# Access Compliance Report

## Public Rights-of-Way

Intersection ID: 29688	Main Street: BIG_PINE_DR	Cross Street: EQUESTRIAN_DR	Location: SE
ADA ID: 1C7E47EB618B	Ramp Type: BlendTrans1	Initial Pass/Fail: Fail	Overall Compliance: No
Severity Score: 8.75			
Codes/Mitigation Info/Possible Solution		Field Measurements/Component Compliance

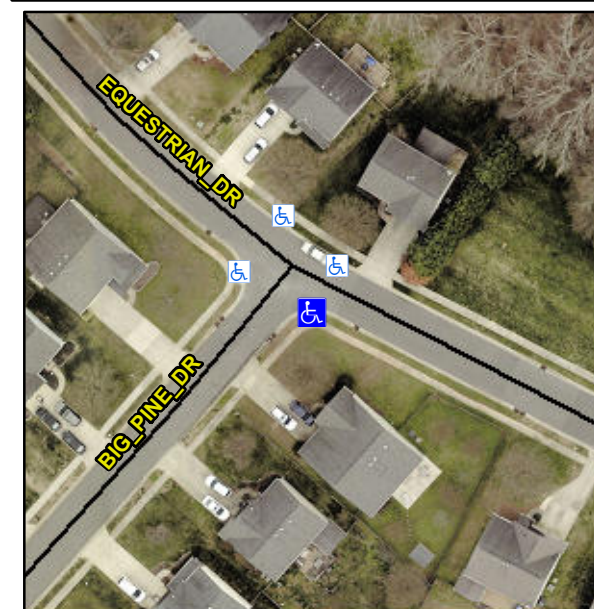
**Remove & Replace Curb Ramp With Two New Directional Ramps or Equivalent.**

**Not Found, R304.5.1**
